V2500-A5 SERIES PROPULSION SYSTEM NON-MODIFICATION SERVICE BULLETIN

This document transmits the Initial Issue of Service Bulletin EV2500-72-0446

NON-MODIFICATION – ENGINE – INSPECTION OF TURBINE EXHAUST CASE LEADING EDGE PRESSURE
AND TEMPERATURE VANES

Turbine Exhaust Case – Inspection Zones
Figure 1

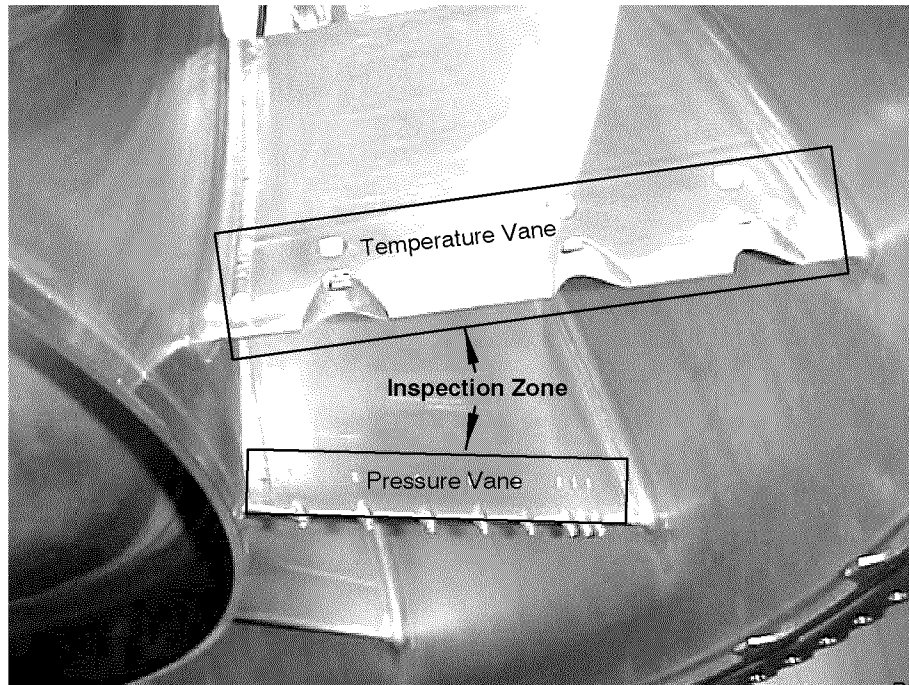
- (1) Verify with a magnet that the leading edge of the three Pressure Strut Vanes, and four Temperature Strut Vanes exhibit magnetic properties. Suspect struts have a forged leading edge with either 'V' cuts or integral tubes protruding. Acceptable material will attract the magnet. Any questionable material can be further tested as follows:

- (iii) Contact probe tips to setting gage TAM 99603. Apply the cold tip to the specimen before the hot tip. The meter readings for the gage shall be minus 80 to minus 95.
- (iv) If instrument reading is not within tolerance specified, send to Gage Standards for repair.
- (v) Perform the inspection by placing both of the probe tips on the Leading Edge of the seven struts to be inspected, applying the cold tip to the leading edge before the hot tip. Material is acceptable if the instrument readings are within the specified limits for Greek Ascoloy per Table 1.

- (viii) 5. When finished, turn the power switch to the center position marked 'OFF'. The unit should be plugged in as necessary to recharge the battery when using the DC operation.
- (b) If VANE tests prove material is not acceptable, remove engine prior to 2700 cycles.
 - (i) If any cracks are detected contact IAE for a detailed management plan.
- (2) Disposition.
 - (a) Report all results (Acceptable or Non-acceptable) to IAE.
- (3) Recording Instructions
 - (a) A record of accomplishment is required.
